COUNCIL ASSESSMENT REPORT

Panel Reference	PPSSCC-233
DA Number	DA 1406/2021/JP
LGA	The Hills Shire Council
Proposed Development	Demolition of Existing Structures and Construction of 3 Residential Flat Buildings, 5-7 Storeys in Height Comprising 261 Units and Basement Carparking
Street Address	21 – 31 Hughes Avenue Castle Hill 38 – 40 and 42A – 50A Middleton Avenue Castle Hill
Applicant	Australian Consulting Engineers Pty Ltd
Consultant/s	Town Planner - Sutherland & Associates Planning Architects – Turner Architects Surveyors - Canda Surveyors Landscape Architect – RPS Contamination Report – Environmental Investigations Traffic – Varga Traffic Planning Flood Report – SGC Consulting Engineers Acoustic Report – Koikas Acoustics Arboricultural Assessment – Birds Tree Consulting BCA Report – McKenzie Group BASIX Report – Windtech Waste Management – Elephants Foot Access Review – Morris Goding & Associates Wind Assessment – Windtech Stormwater Concept – SGC Consulting Engineers Sustainability Report – Northrop Quantity Surveyors – Construction Consultants Legal advice – HWL Ebsworth

Figure 2: Image indicating extent of height exceedance

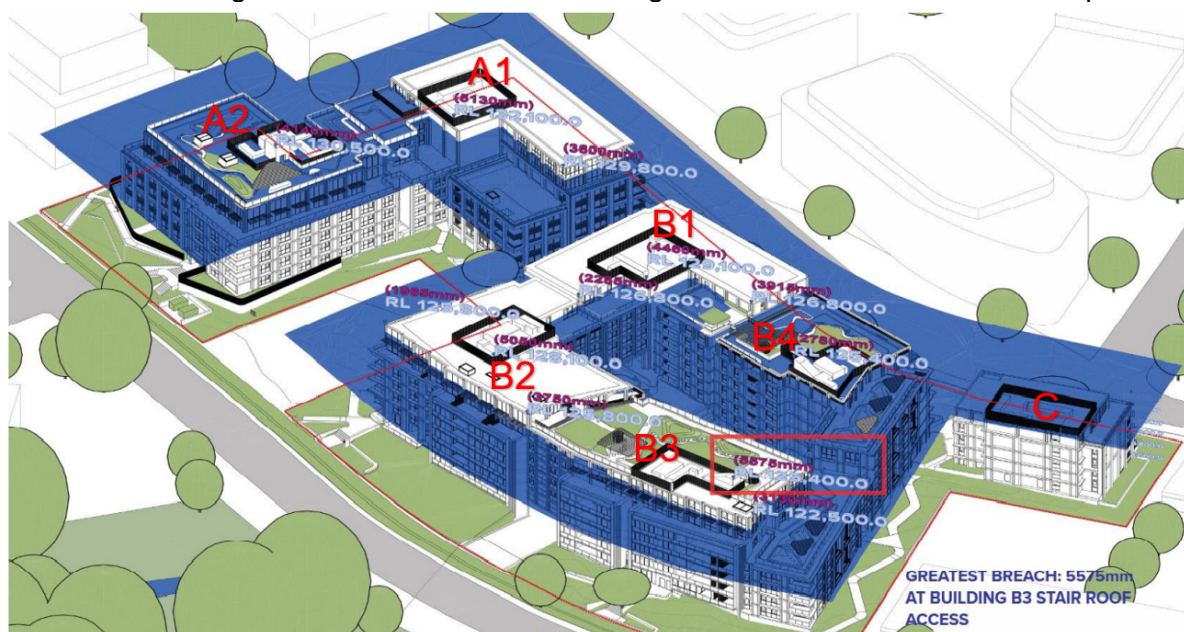
constraints on the land which requires the finished floor levels of the residential buildings to be above the 100-yr ARI flood level. Notwithstanding this, the variation to the height standard will not cause adverse impacts on the amenity of adjoining properties with respect to overshadowing, privacy, view loss and perceived bulk and scale. The largest variation to the height standard occurs to Building B, where Building B3 comprising a 5.57 metre (26.5%) variation and Building B2 with a 5.05 metre (24%) variation. This relates to stair roof access to communal open space and lift overruns/plant services. Similarly, the largest variation to Building A comprising a 5.13 metre (24.4%) variation relates to a lift overrun. Whilst a portion of the habitable floor areas of the buildings A and B exceed the maximum height plane, the portion of these buildings are setback approximately 4m from the building façade and not immediately to the south of the development. The buildings directly adjoining the southern property boundaries are only four to five storeys in height which is approximately one to two storeys below the maximum height standard permitted on the site. These buildings are set back between 6 metres to 7.5m from the southern property boundaries. This provides an appropriate transition to the adjoining R3 Medium Density zone and would result in a reduction of overshadowing impacts compared to a scheme that fully complies with the height standard along the southern property boundary.

This, together with the generous front and upper-level setbacks, the well-articulated design is considered to integrate with the form of the building when viewed from the streetscape.

Figure 6: Diagrams demonstrating a balanced approach to adjoining development

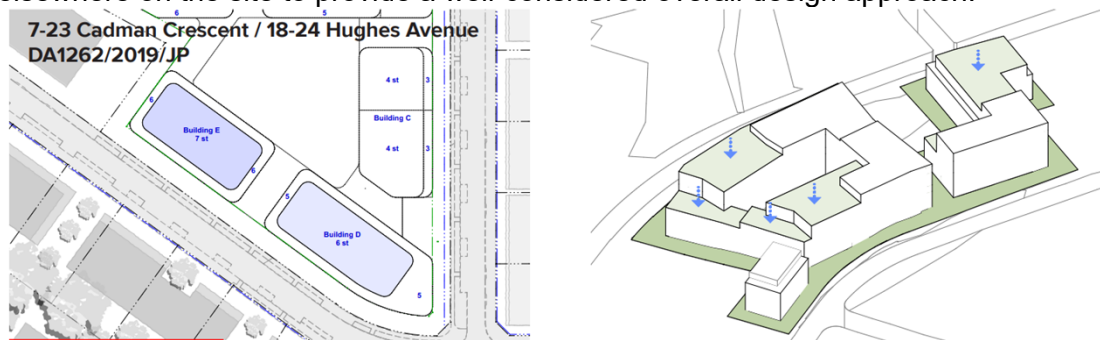
- 1) The DCP primary and secondary setback non-compliances should be revised to ensure sufficient residential amenity and that the desired future character of the showground precinct and the garden shire identity is retained. The applicant has not provided a sound urban design justification for this non-compliance.

- 1) The DCP setback and height requirements are typically adhered to. Variations to this are consistent with the approval for the masterplan for the site on the opposite side of Hughes Avenue under DA1262/2019/JP where the 'shoulder' of the building has been increased from 4 storeys to 6 storeys, and the main portion of built form has been increased from 6 storeys to 7 storeys. The proposal for the subject site is consistent with this contextual benchmark. While the proposal incorporates minor encroachments into the Hughes Avenue setback and height plane, there are also many elements of the built form that have setbacks and built form height reductions that well within the controls to respond to contextual and amenity requirements. The minor encroachments are therefore not a requirement of FSR so much as a balance in reducing volume elsewhere on the site to provide a well-considered overall design approach.

Figure 10: Diagram indicating solar access to isolated site

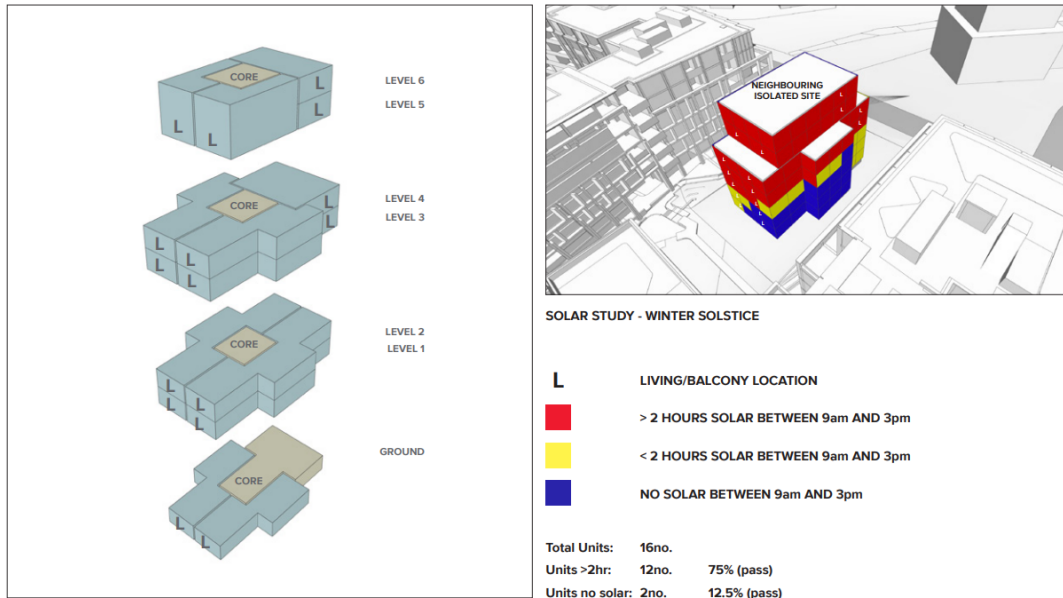
- 5) The isolated site has a considerable impact on site planning and the ability to achieve the maximum FSR whilst retaining appropriate residential amenity. The Panel also acknowledges that the applicant has made persistent but ultimately unsuccessful attempts to secure the missing site.

- 4) The geometry of Building B1 has been adjusted to increase the distance between Building A1 and B1. The configuration of apartments in Building A1 have also been amended so that the bedroom that was previously facing B1 is now facing the open courtyard. All habitable rooms are now compliant with the ADG separation distances.
- 5) The following diagram outlines that the layouts and built form of the neighbouring site at 42 Middleton Avenue have been considered and that amenity is afforded to it by way of solar access.

Figure 12: Central Courtyard Detail Plan

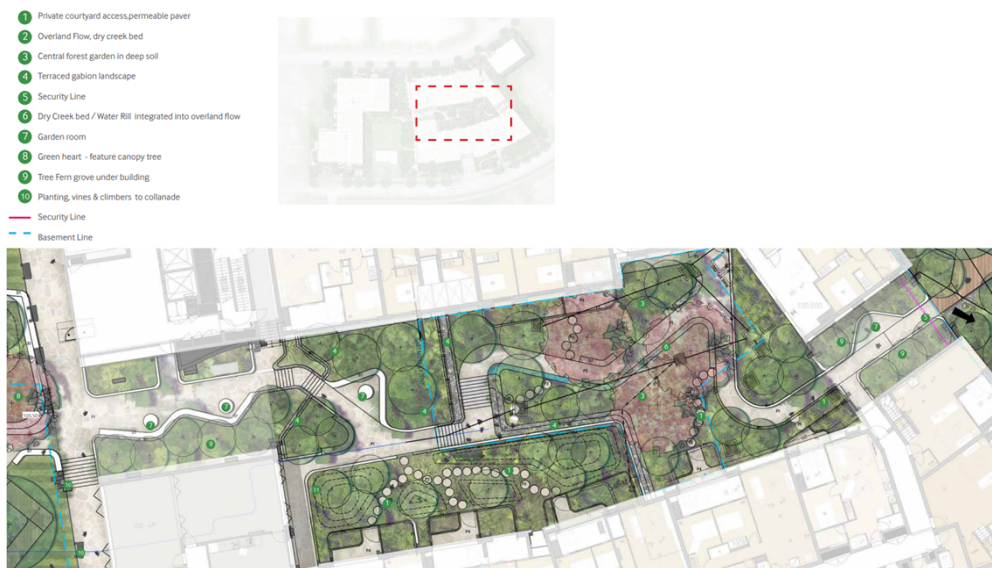
- 10) The central courtyard is dominated by circulation paths. More opportunities for amenity and useable spaces should be provided in the central yard. The access walkway immediately south of Lot 9 appears to be restricting tree planting in this area. Reconsider the layout of the walkway in this area to allow additional tree planting and additional useable amenity / informal seating areas.

10) A response has been provided by the Landscape Architect indicating that the central courtyard provides a passive recreation space for all residents with opportunities for informal quiet seating areas, safe informal play spaces for children, discovery play elements nestled in fern gardens, natural elements such as water and planting, nature play for children and an urban oasis reducing the heat island effect. The central courtyard also provides dense planting allowing internal facing apartments to connect to nature and have a view out to the tree canopy. Refer figure below.

Figure 14: Existing Conditions 1% AEP Flood Level

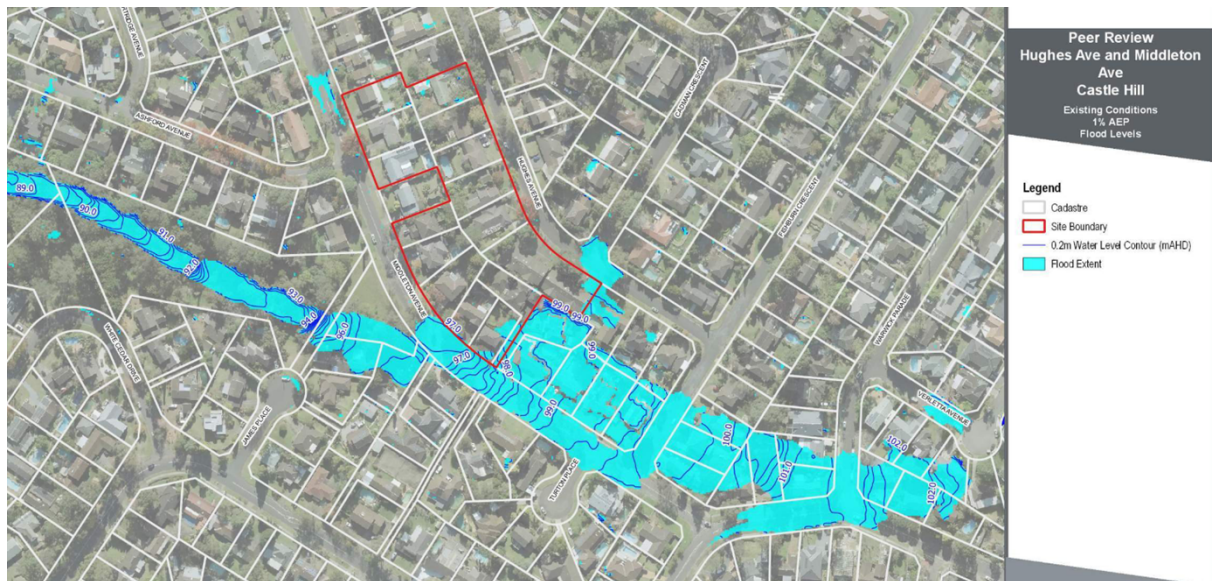
The Applicant has submitted a hydrological model (DRAINS) of the local catchment which estimates the runoff during the 10% AEP, 5% AEP and 1% AEP critical storm bursts. A local hydraulic model (TUFLOW) of the floodplain was also submitted which converts the catchment runoff into 10% AEP, 5% AEP and 1% AEP flood levels, depths, velocities and flood hazard categories under existing and future conditions.

Figure 3: Level 6 Floor Plan indicating separation distance to 42 Middleton Ave

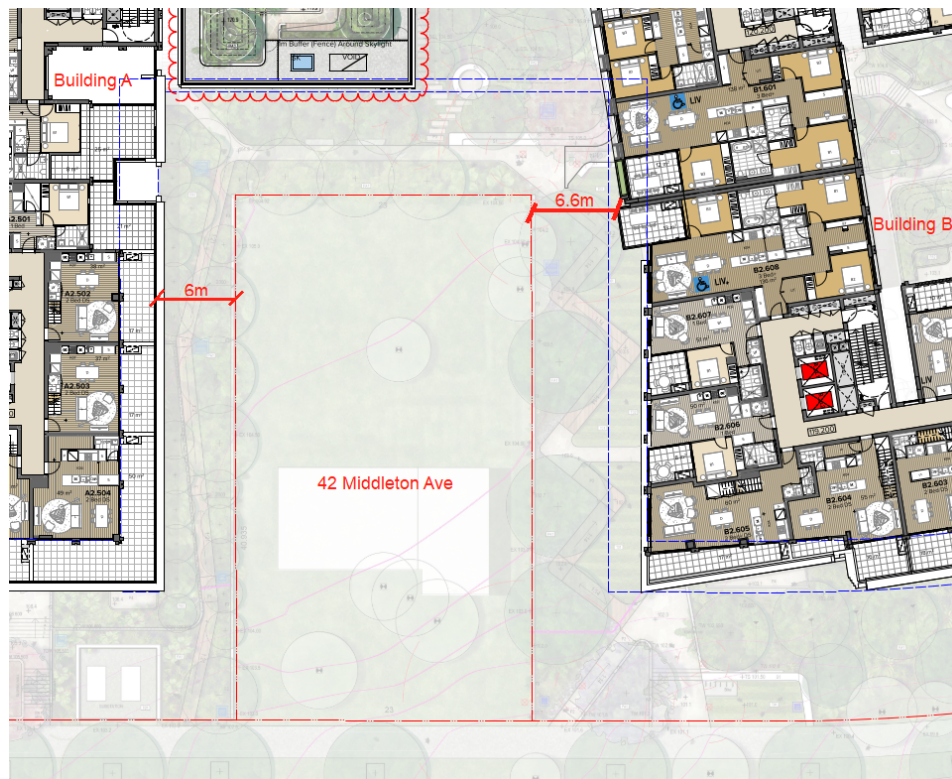
Whilst most habitable rooms and windows meet the building separation distances as required under the Apartment Design Guide, several balconies/habitable room windows in upper-level units between Buildings A and B and from Buildings A and B to a future development at No. 42 Middleton Ave do not meet the design criteria of the Apartment Design Guide (as detailed

in Table 1). Notwithstanding, all relevant balconies and windows are angled or will be conditioned to contain privacy mitigation measures such as privacy screens to minimise direct overlooking (refer Condition 1). Condition 1 recommends that all balconies facing No. 42 Middleton Avenue that encroach within the required ADG design criteria will require the installation of 1.8m high privacy screens.

Figure 15: Front setback variations

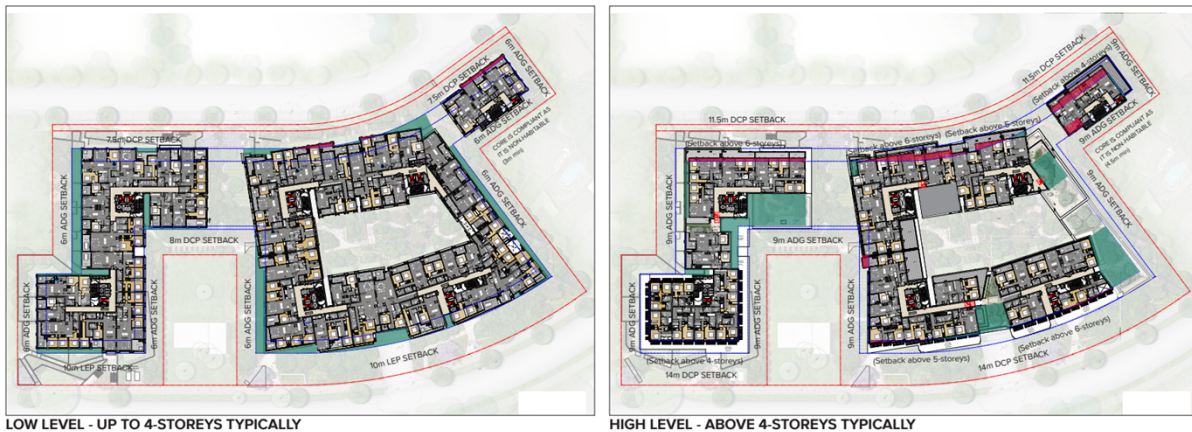
The DCP requires a 7.5m setback from Hughes Avenue and that storeys above the fourth storey shall be setback a minimum of 4 metres behind the front building line. Variations occur to the required setbacks as highlighted in red in the below figure.

A lower-level minimum setback of 6m is proposed for Building B and 6.2m for Building C. For buildings A, B and C, the fifth storey and above are setback a minimum of 3 metres behind the front building line (refer to figure above). This does not strictly comply with the numeric controls.

Figure 17: Landscaped Open Space Areas

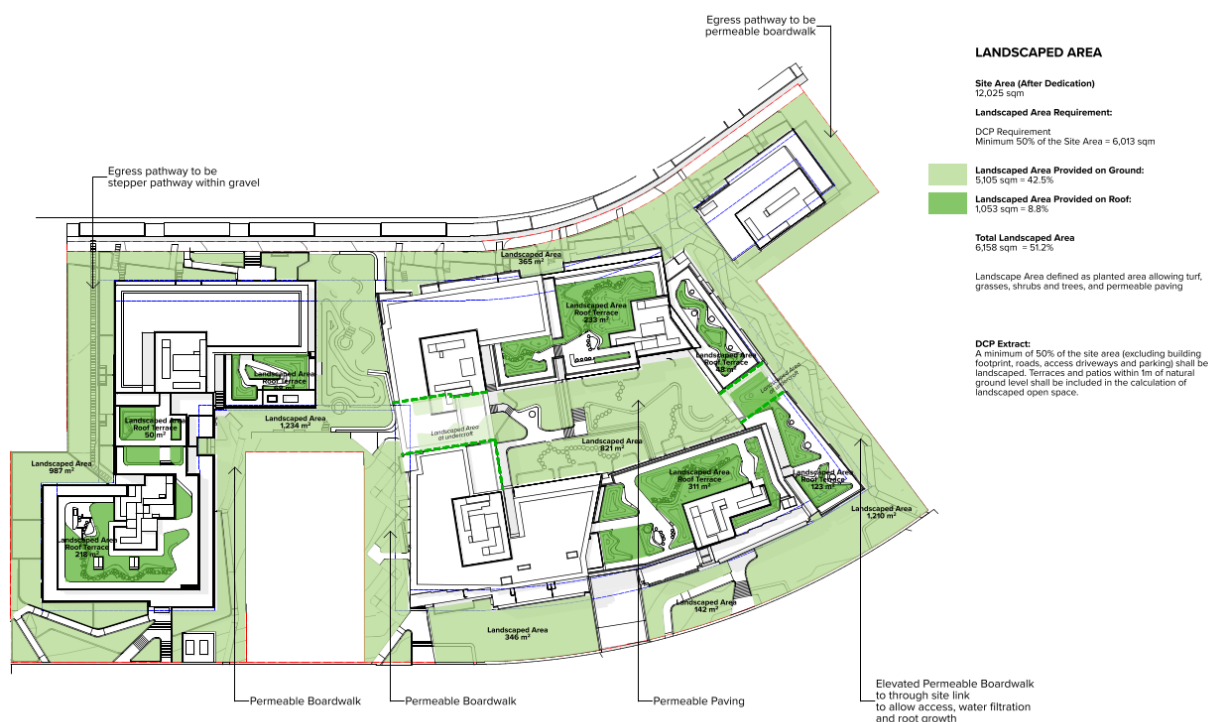
The DCP requires that a minimum of 50% of the site area (excluding building footprint, roads, access driveways and parking) shall be landscaped. Terraces and patios within 1 metre of natural ground level shall be included in the calculation of landscaped open space. The development proposes 42% of the site area to be landscaped, resulting in a variation of 8%.

The Applicant submits that the proposal complies with the landscaping control if the rooftop communal open space areas are included in the calculation as demonstrated in the below figure.
